February 20, 2004

Subject: USNRC Docket No. 72-1014, TAC L23657
HI-STORM 100 Certificate of Compliance 1014
HI-STORM License Amendment Request 1014-2, Revision 2, Supplement 2
Supplemental Response to Request for Additional Information 2

As committed in the Reference 3 letter, we herewith provide Supplement 2 to License Amendment Request (LAR) 1014-2, Revision 2. This supplement provides the modified proposed changes to the HI-STORM CoC and FSAR required to support our responses to the second round RAI pertaining to this amendment request. In addition, as previously discussed, a small number of editorial corrections not related to the RAI are also provided for clarification. All changes submitted with this supplement are summarized in Attachment 1. The following attachments are provided. Enclosed with this letter are instructions for updating the documents in the LAR notebook.

FIGURE 2.C.1: SUPPLEMENTAL COOLING SYSTEM EXAMPLE P&I DIAGRAM

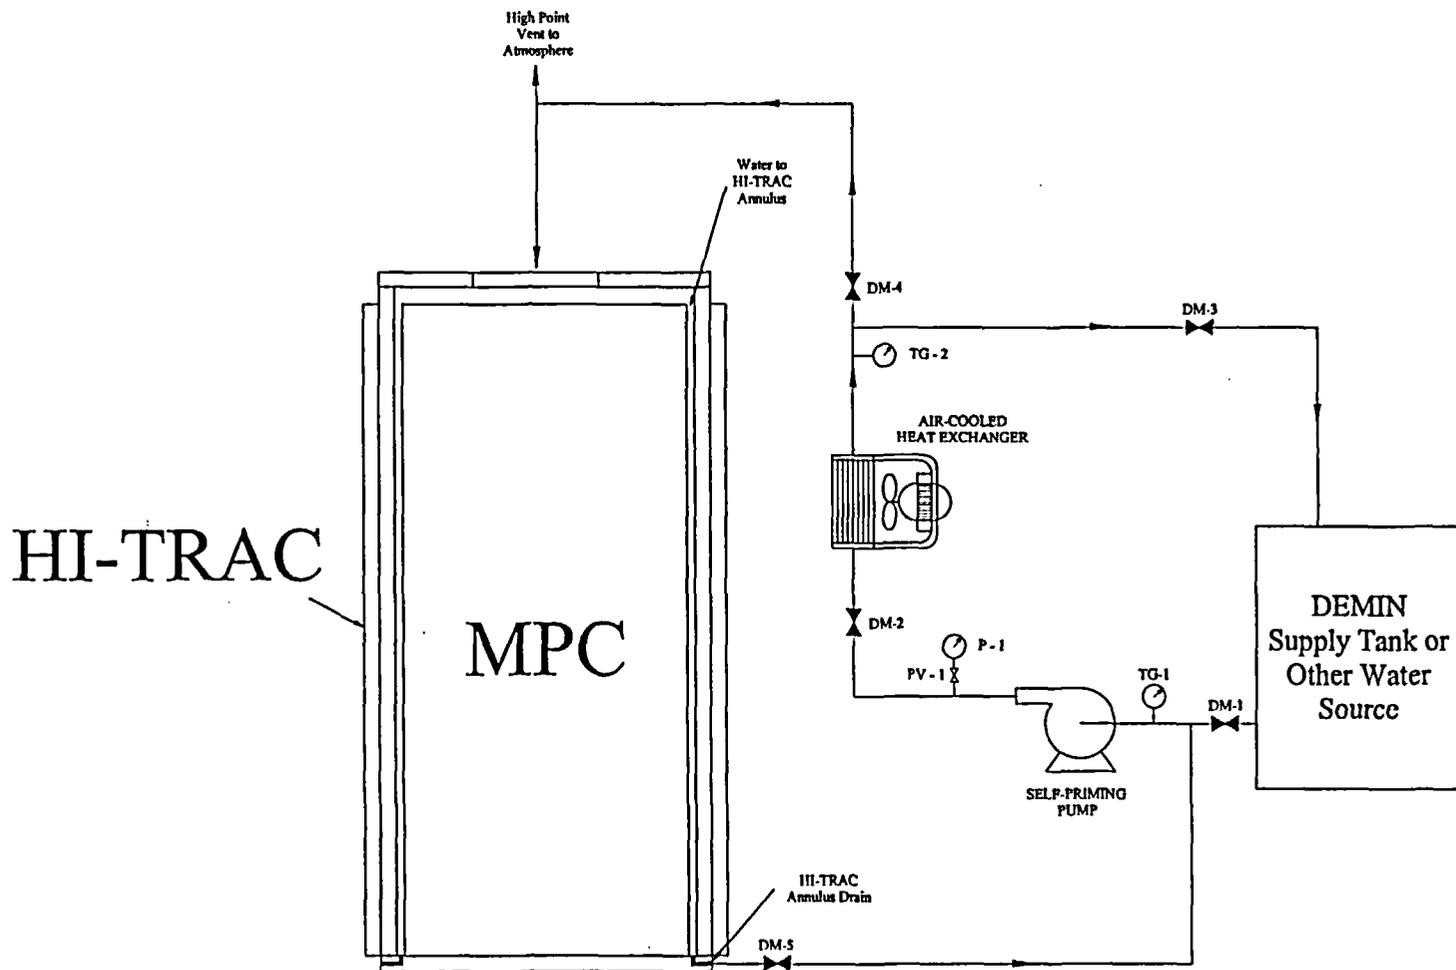
23. Remove FSAR pages 2.6-1 through 2.6-3, Proposed Rev. 2B and replace with enclosed FSAR pages 2.6-1 through 2.6-3, Proposed Rev. 2C.
24. Insert new Appendix 2.C, (3 pages including Figure 2.C.1), Proposed Rev. 2C after existing Appendix 2.B, Proposed Rev. 2B.

- k. Continue the monitoring and moisture removal until LCO 3.1.1 is the acceptance criteria are met for MPC dryness.
- l. If required, connect the Supplemental Cooling System (SCS) to the HI-TRAC annulus (See Figure 2.C.1 for an example configuration).

17. *If required, attach the SCS to the HI-TRAC annulus and begin circulating coolant. (See Figure 2.C.1). Continue operation of the SCS until MPC cool-down and re-flooding operations have commenced.*
18. *If necessary, remove the MPC downloader from the top of HI-TRAC.*
- ~~18-19.~~ Remove HI-TRAC from the top of HI-STORM.

Figure 11.2.8: Peak Cladding Temperature In a Horizontal HI-TRAC

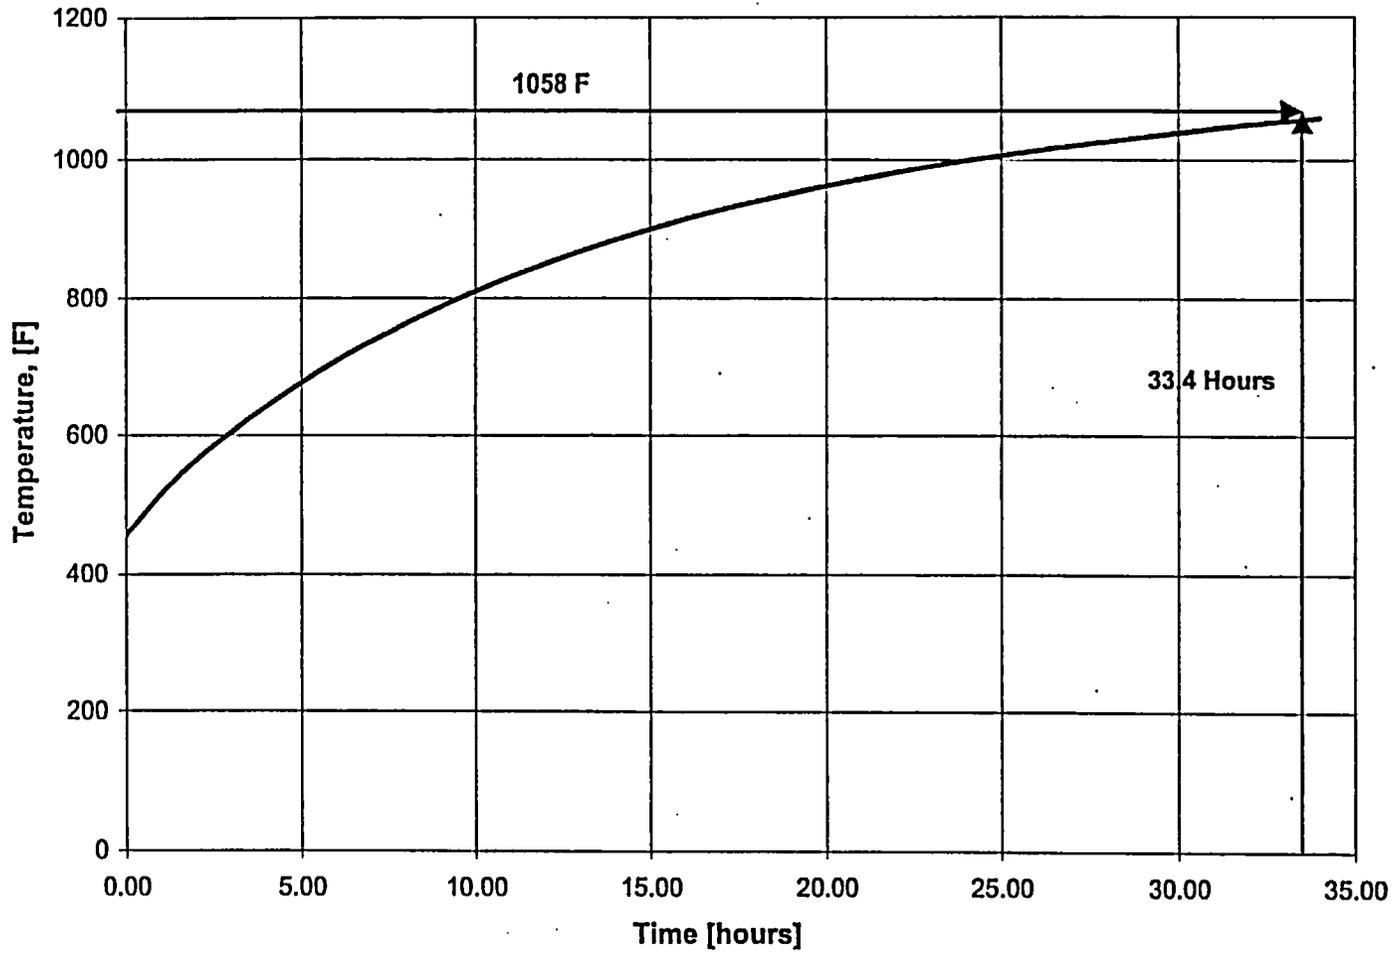
39. Insert new Figure 11.2.8 at the end of Chapter 11.
 40. Remove FSAR pages 12.1-1 through 12.1-3, Proposed Rev. 2B and replace with enclosed FSAR pages 12.1-1 through 12.1-3, Proposed Rev. 2C.
